To: Miles Orlopp, LLFA engineer
From: Caroline Jeanne SLR /
Jeremy Collins GGP
Company: Suffolk County Council
SLR Consulting Limited
cc:
Date: 28 February 2024
Project No. 405.064987.0007

RE: Spring Grove Farm
Lead Local Flood Authority (LLFA) Response

Thank you for your letter in response to the Flood Risk Assessment (FRA) and Surface Water Drainage Strategy (SWDS) (SLR Ref: 404.11923.00004.0005 Version No:1 dated August 2023) for the proposed Anaerobic Digestion Plant at Spring Grove Farm, Withersfield, Northwest of Haverhill, Suffolk, CB9 7SW (the 'Site'). This Technical Memorandum aims to address the objection to the proposed development at the Site regarding the surface water drainage strategy as set out in your email dated 17th October 2023.

Drawing Title Lagoon Details
--

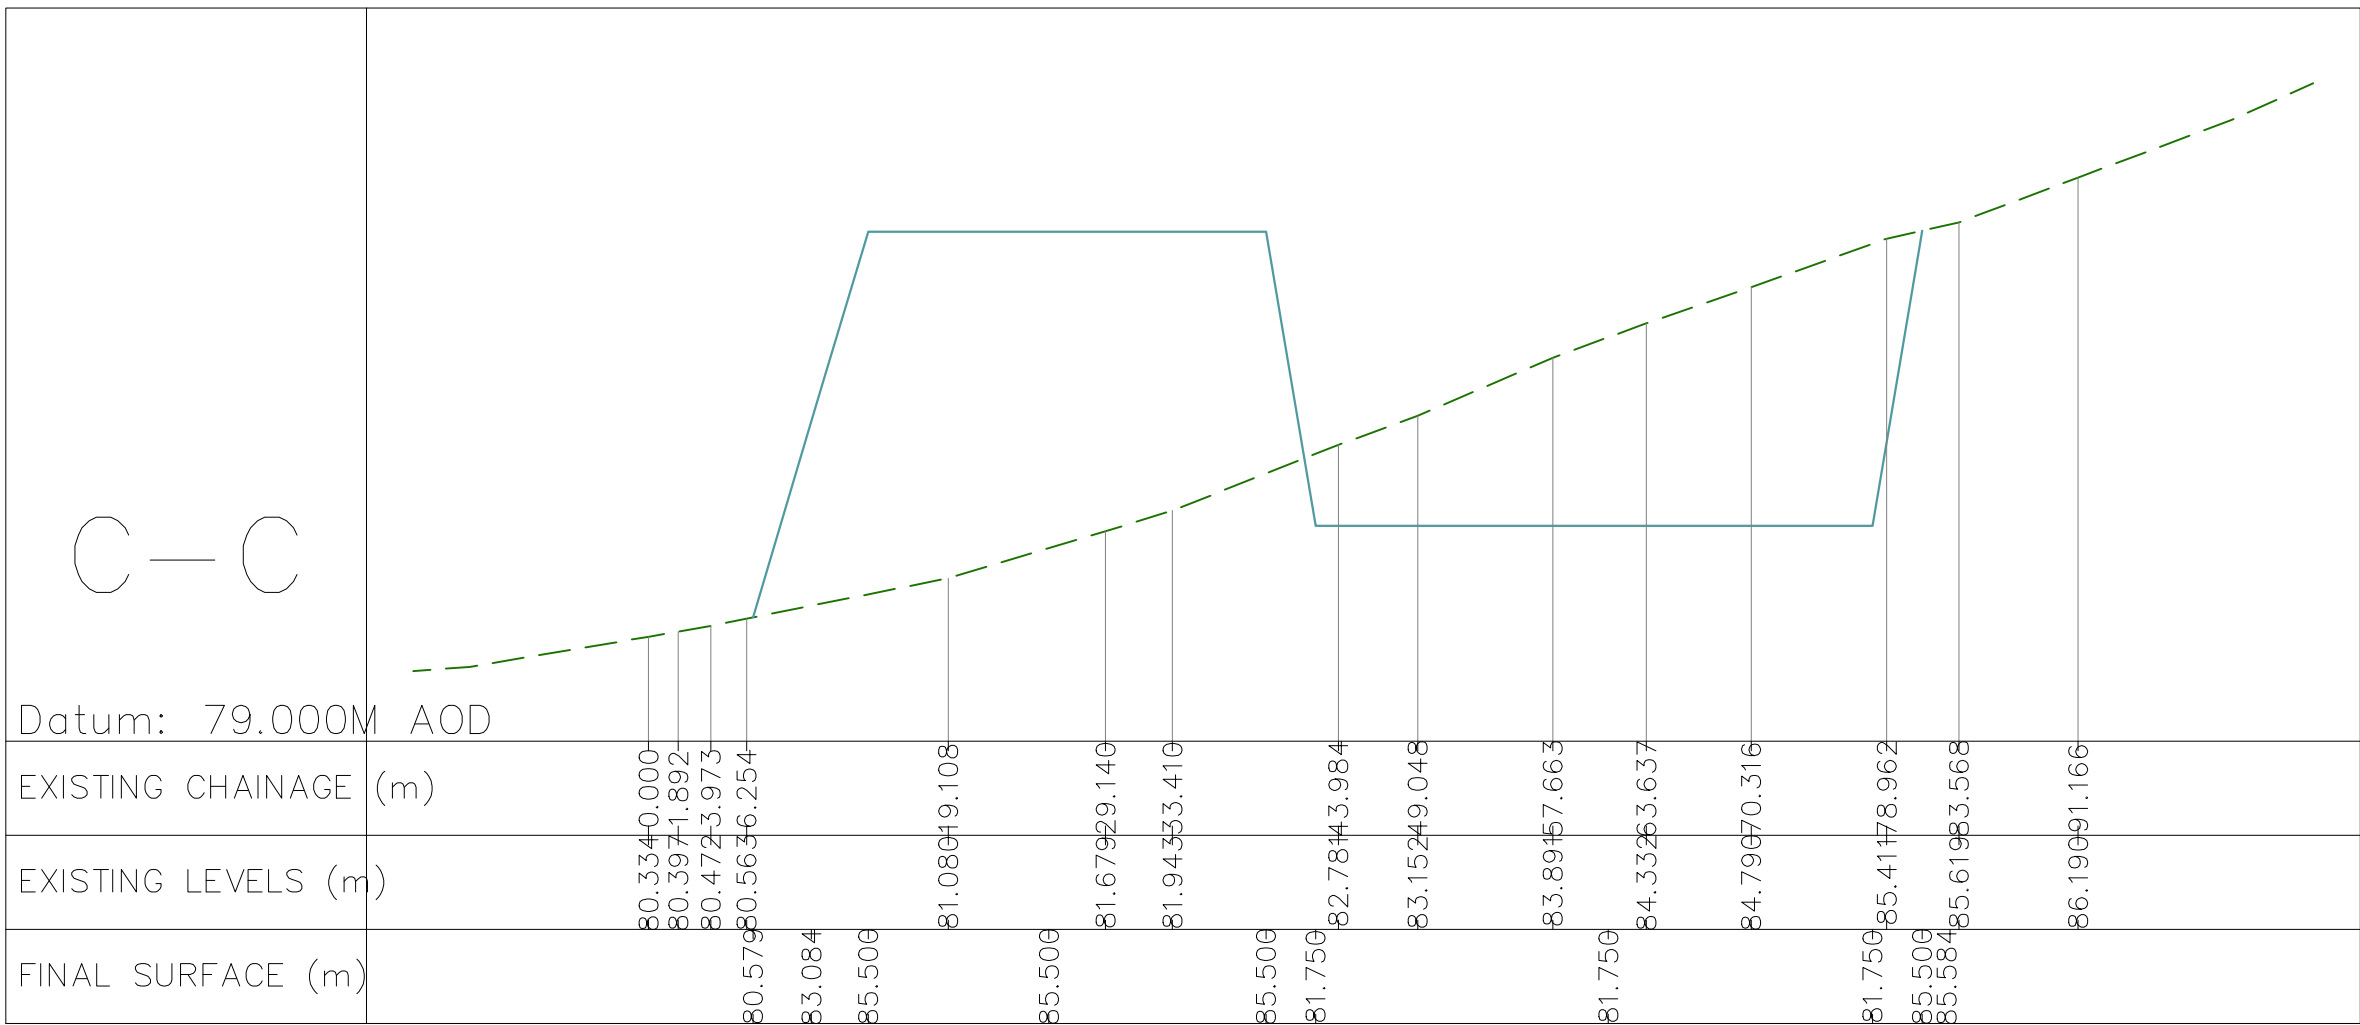
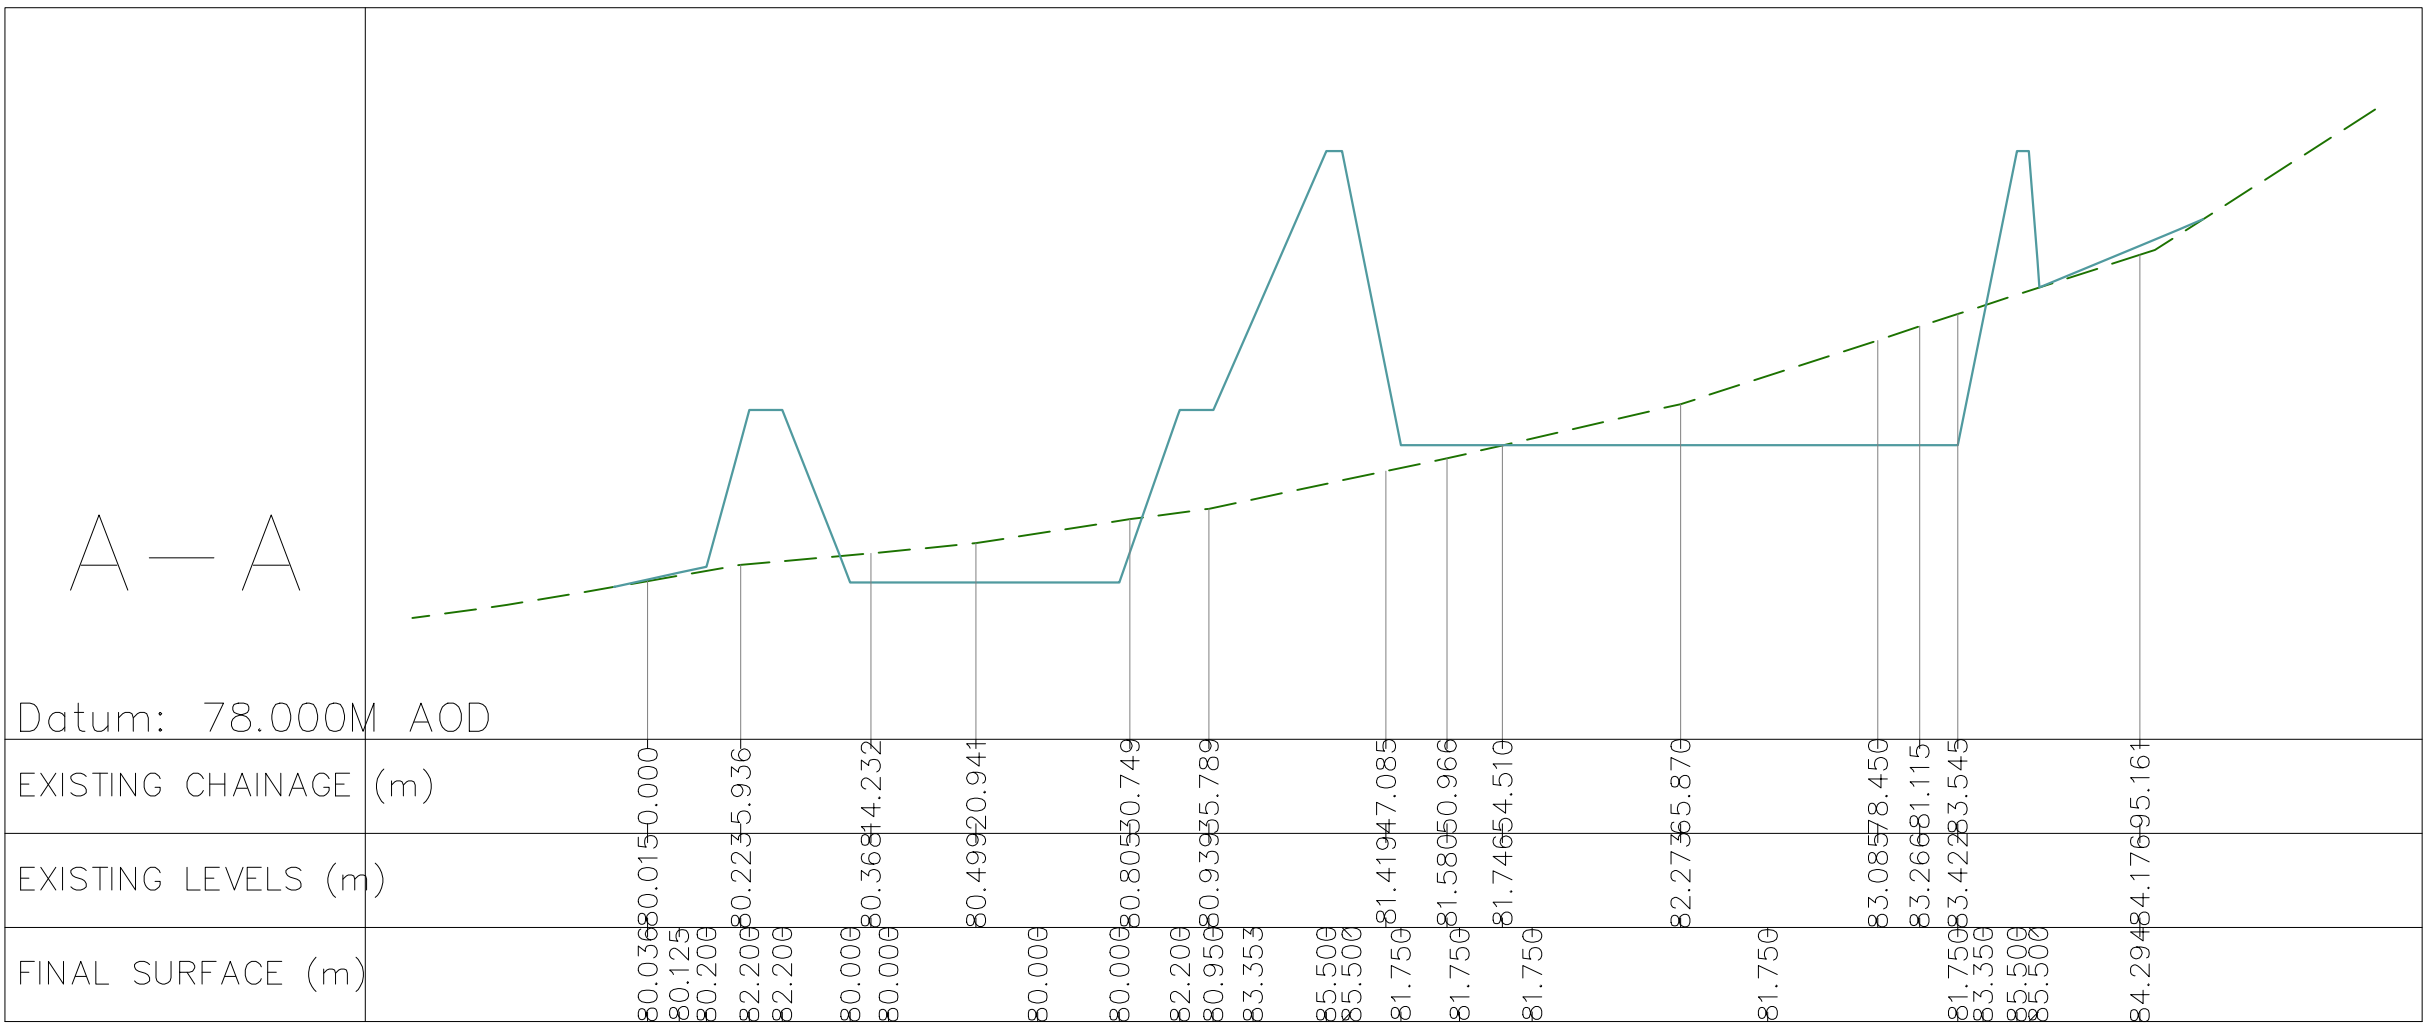
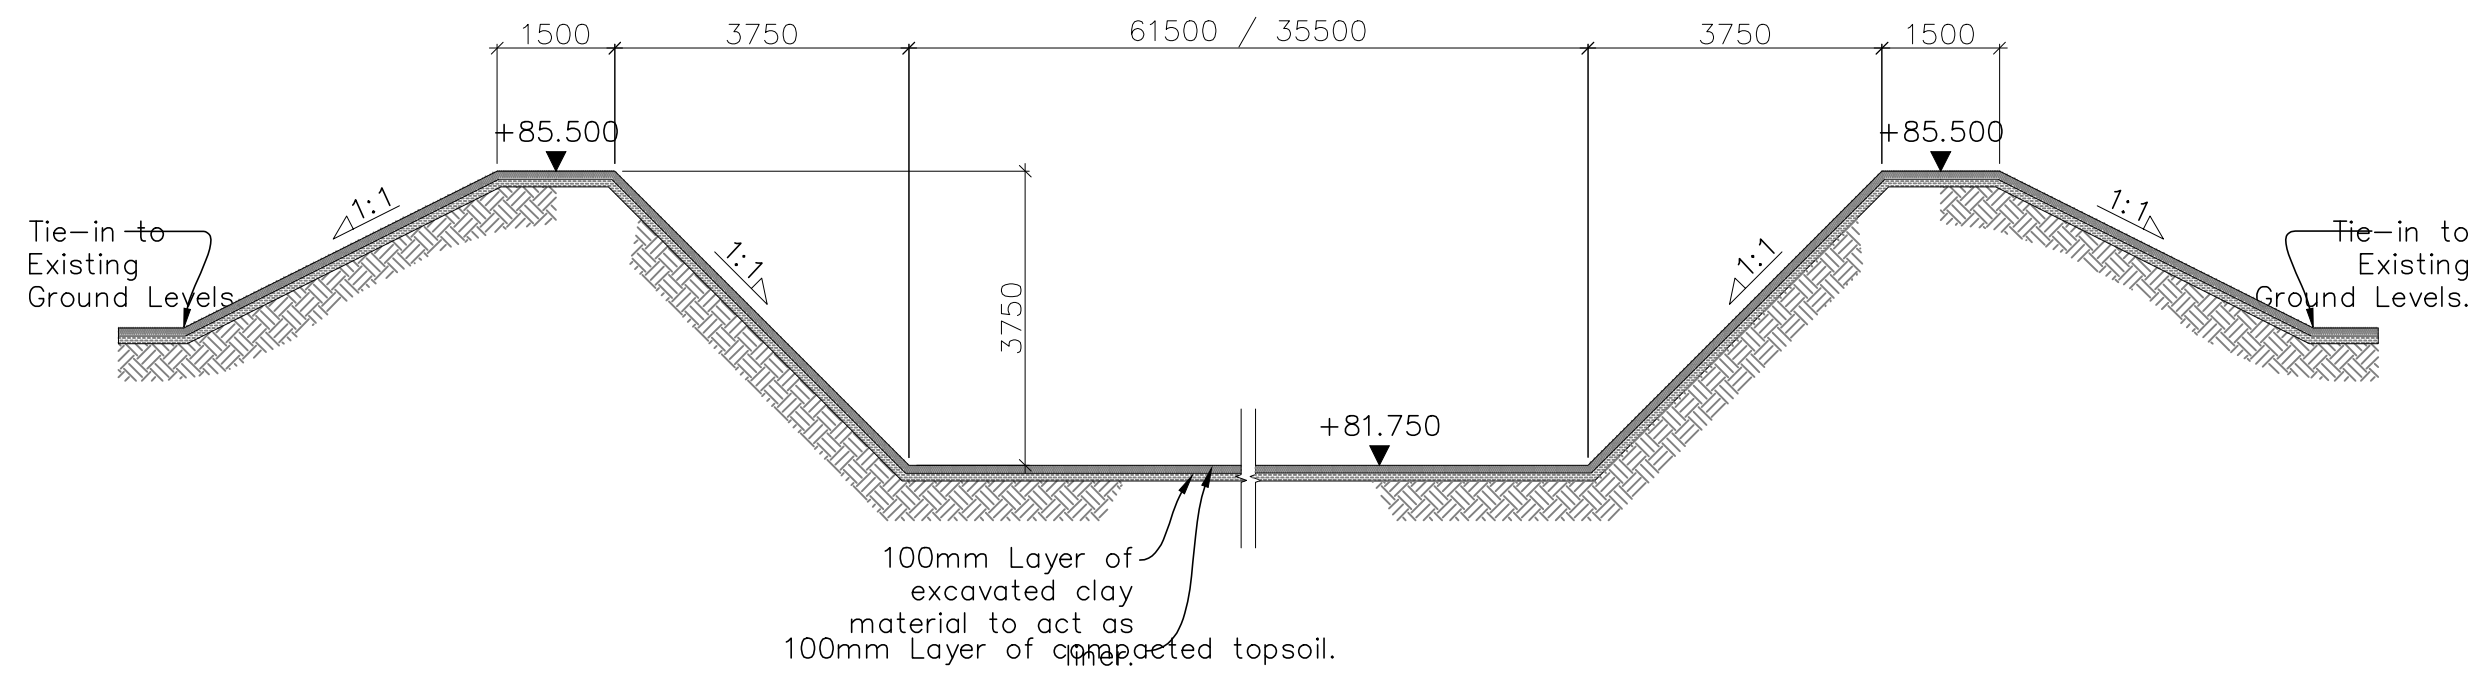
"Detailed SuDS drawings will need to be included within the drainage strategy, i.e., cross, and long sectional drawings. All features should be designed in accordance with Suffolk SuDS Guidance. We also expect to see a contour plan, exceedance routes and impermeable area drawings included within the drainage strategy".

- GGP-29351-P-105-C Drainage Plan;
- GGP-29351-P-121-C Proposed Lagoon Details;
- GGP-29351-P-105a-C-Drainage Catchment Plan.
